Subject: 171527 - St Weonards

Thank you for your response to my e-mail dated 22nd May 2017 requiring further information and seeking consistency between the submitted documents. Inconsistencies remain.

TITLE
SITE PLAN
LAYOUT
NUMBER
231 PL 02 A

THE DUCHY OF CORNWALL
ST WEONARDS
HEREFORDSHIRE
FRANCIS ROBERTS ARCHITECTS
1 RIBBLESDALE PLACE, PRESTON PR1 3NA
T 01772 562221 E architects@francisroberts.com

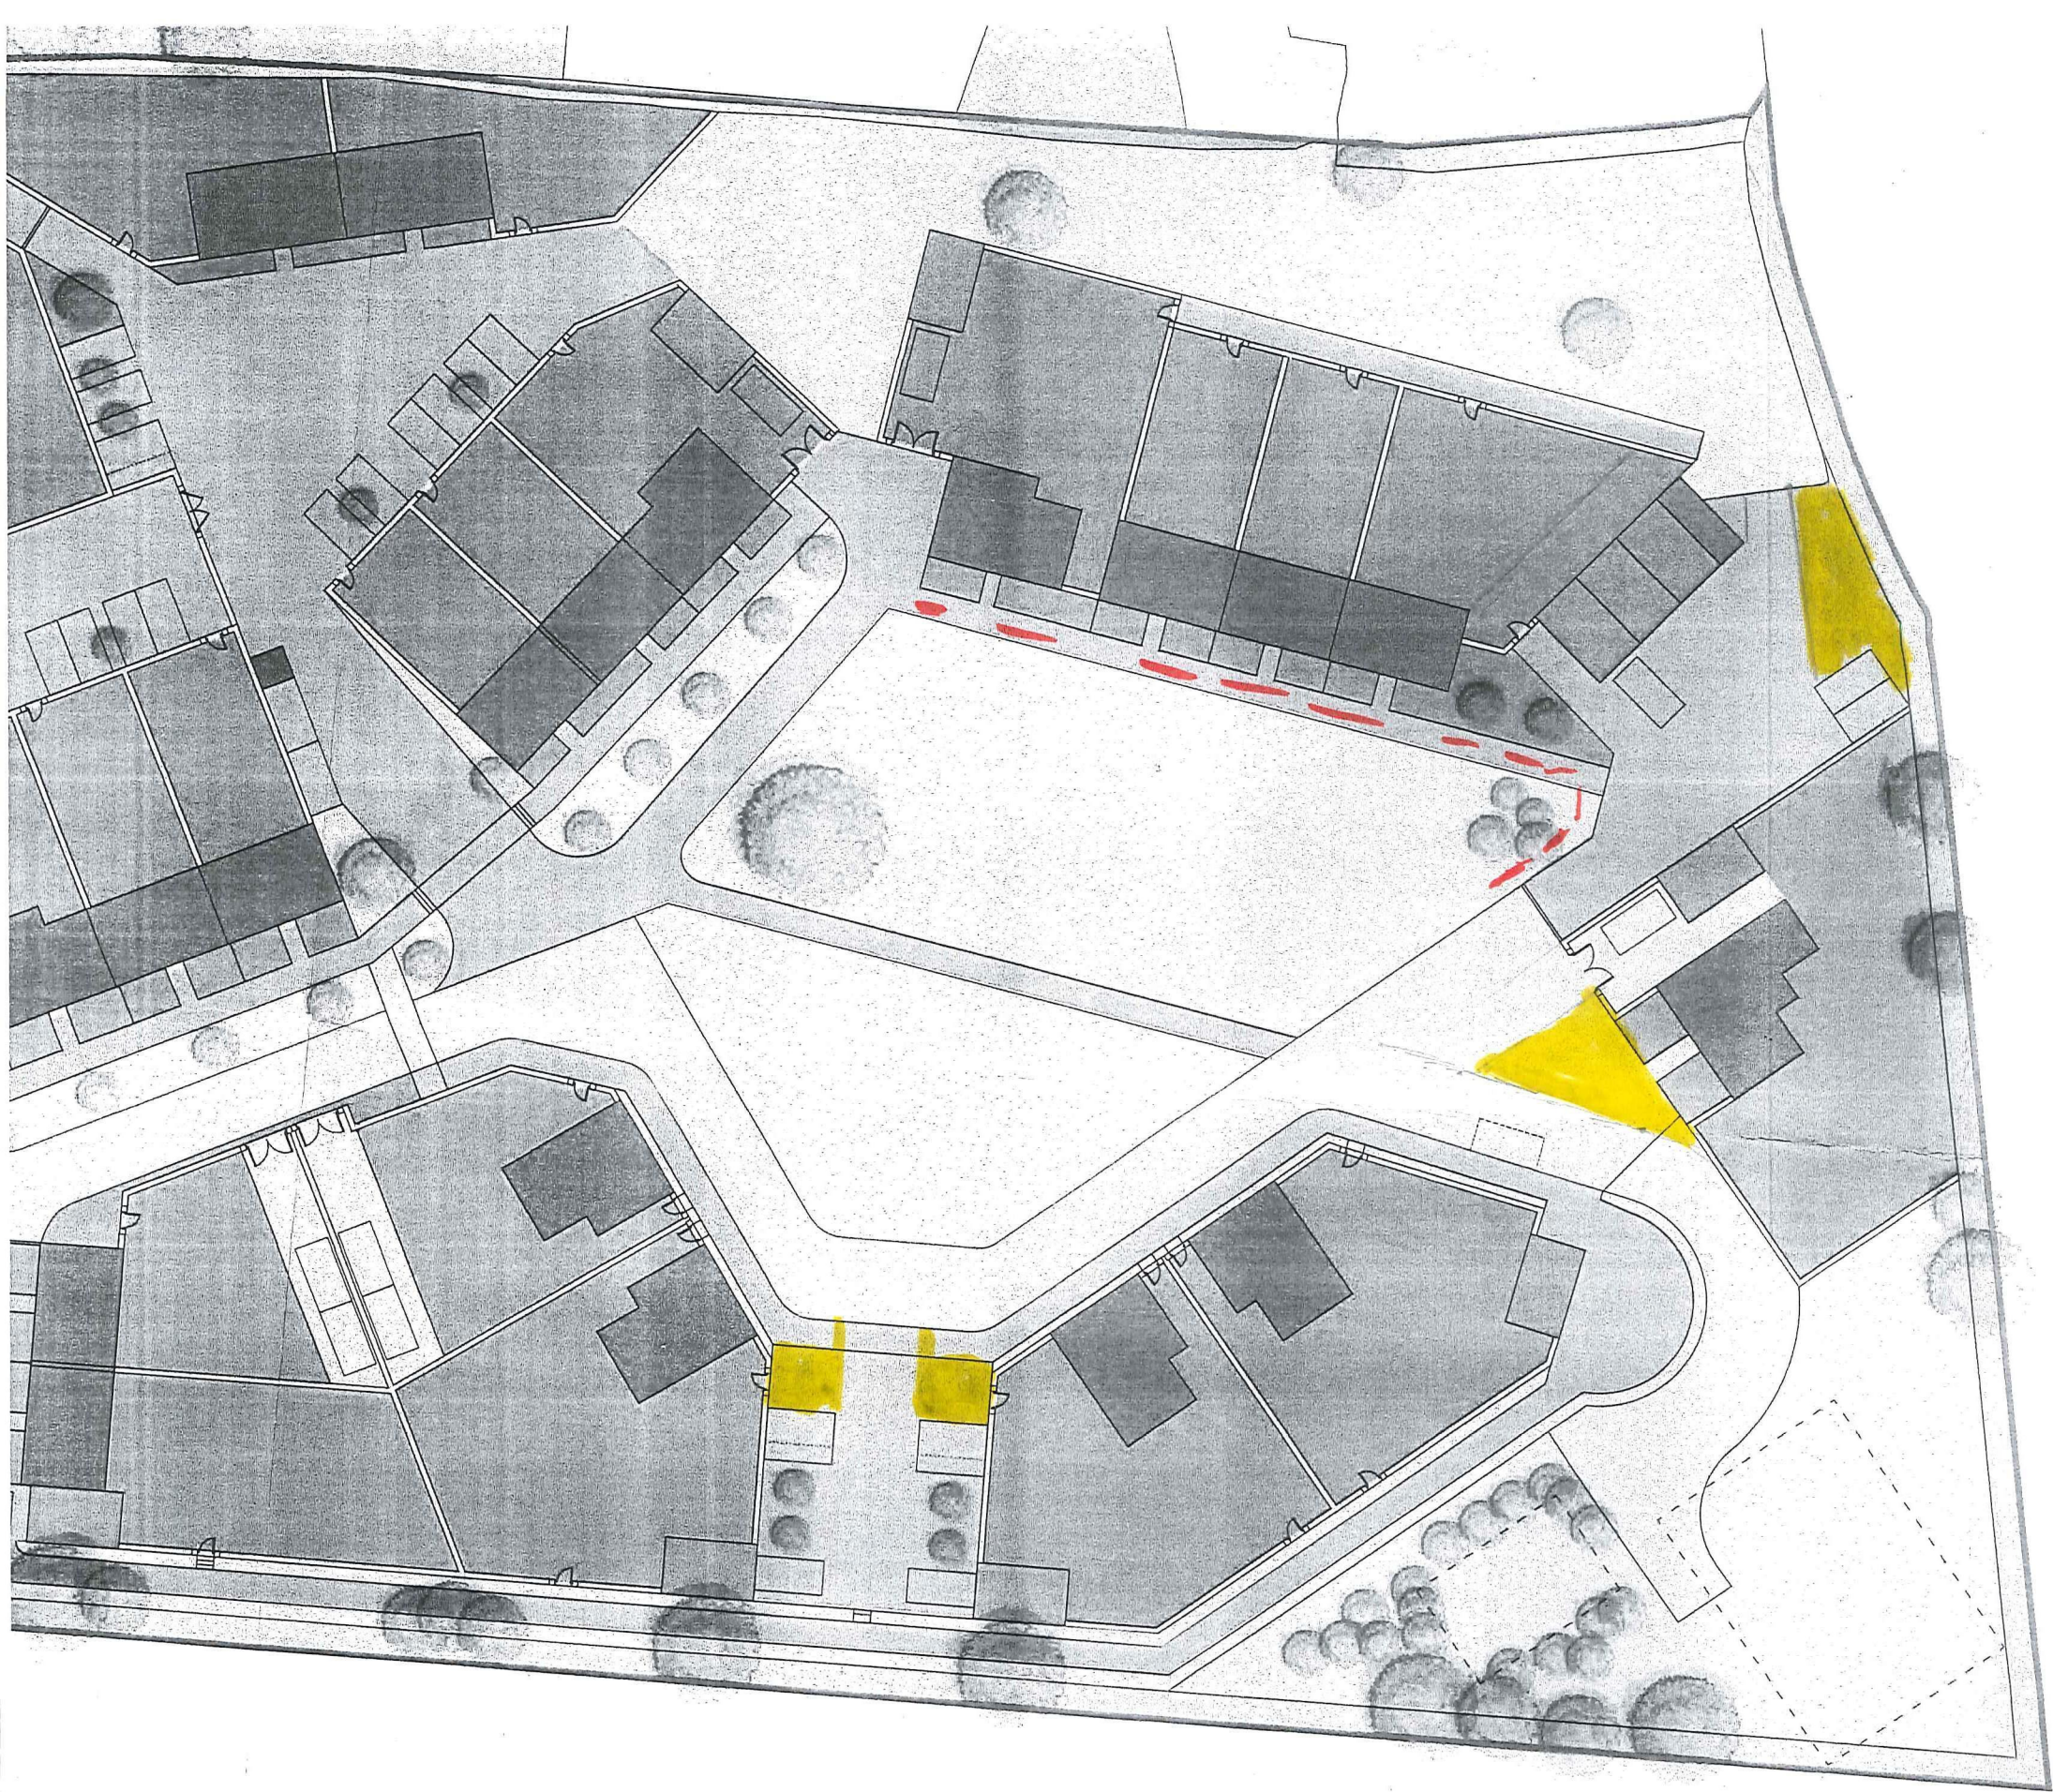
I am concerned that the scheme appears to include unnecessarily large areas of hardsurfacing for the manoeuvring of motor vehicles. This not only has an impact upon the landscape but creates a vehicle dominated environment that I know the Duchy are keen to avoid. I highlight on the attachment above (in yellow) some areas where I consider that hardsurfacing could be reduced. This element of the scheme requires careful attention. I think that at our forthcoming meeting the presence of a Highway Engineer from your side will enable us to explore the matter in more detail.

I fail to understand why a parking space for Plot 13 remains out of curtilage. Surely one can re-site the garage such that there is a car parking space in front of it?

I am not convinced by the attached garage design to Plot 5. Would this not be better as an attached "lean-to" as opposed to the current valley / gulley arrangement?

Revision A: Amendment 01/06/2017
Parking space plot 13 moved away from footpath
Garage Plot 05 altered to agree with drawing 231 PL41
